Product Change Notice Number: **USB3140 D PCN 20170713**

Product Identifier: **USB3140-30-XXXX-X-C**

Drawing Revision Letter: **D**

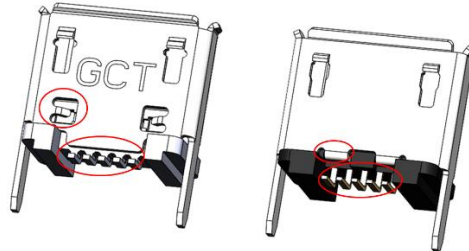
1. Change in solder tail width & length from 0.25 to 0.30mm, 1.50 to 1.18mm & housing dimension from 3.40 to 4.00mm:

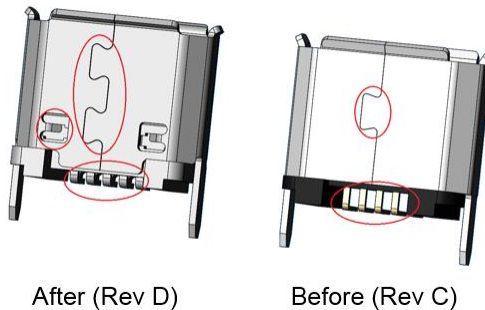
2. Change in shell & housing structure (Illustration below shows Shell stake 2.3mm version):
